**SAFETY RECALL BULLETIN**  
**NHTSA SAFETY RECALL: 16V-088**  
**TRANSPORT CANADA RECALL: 2016067**  
**Iowa Mold Tooling Co., Inc. Safety Recall TB2016002**

<b>Classification:</b>	<b>SAFETY RECALL BULLETIN – MANDATORY MECHANICAL</b>
<b>Subject:</b>	IMT Series III Telescopic Crane Valve Bank Cover
<b>Attn:</b>	IMT Customer/Owner
<b>Date:</b>	March 2016
<b>Safety Recall Information:</b>	This document provides work instructions to replace the valve bank cover on IMT Series III cranes manufactured between 04/04/13 through 01/22/16.
<b>Affected models:</b>	2013-2016 IMT Dominator-Propane, Dominator 1, Dominator 2, Dominator 3 and Dominator 4 vehicles fitted with Series 3 crane models 6000, 7500, 8600, 9500, 10000, 12000 and 14000 that were built with a certain valve bank cover

Fig 1

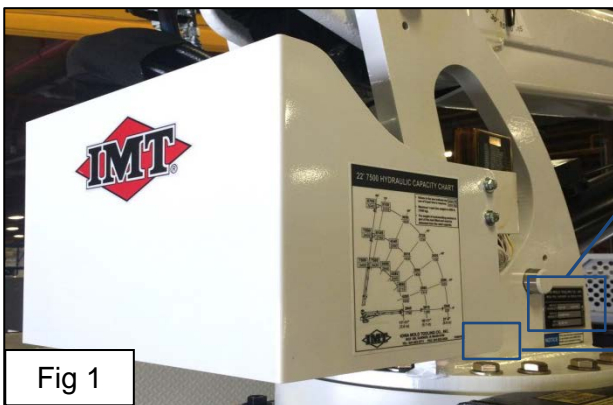
**Why are you receiving this bulletin?** IMT has identified cranes built with a certain valve bank cover on the back side of the crane mast that can crack. Under certain road conditions the cracks can propagate and eventually cause the cover to break. If not repaired, a broken valve bank cover can detach from the vehicle and create a possibility of a road hazard which could result in a vehicle crash or injury.

**What will we do?** IMT has developed a new valve bank cover, made from thicker, high strength steel. We will provide a new cover, with the appropriate decals installed, to you at no charge. IMT will reimburse you for one-half hour of labor to remove the old cover and install the new cover. Cranes manufactured on and after 01/25/16 have the new valve bank cover. The new valve bank cover has an identifying feature (see Fig 2) on the forward, bottom edge.

Fig 3

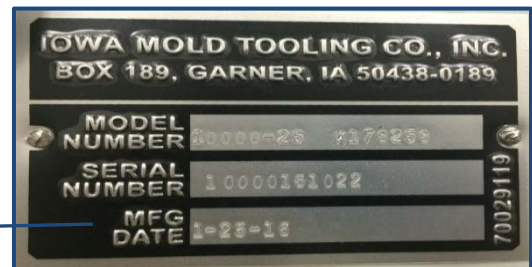
**What should you do?** If your crane was manufactured between 04/04/2013 and 01/22/2016 (the manufacture date is on the serial plate on your crane – see Fig 3) you will need to fill out the attached order form and send it to IMT. Once you have the new cover, remove the old cover and discard it. Installation instructions will be supplied with the new cover.  
**Please be reminded that it is a violation of Federal law for you to sell or lease any IMT crane covered by this notification until this recall has been performed on these vehicles. Substantial civil penalties apply to violations of this law.**
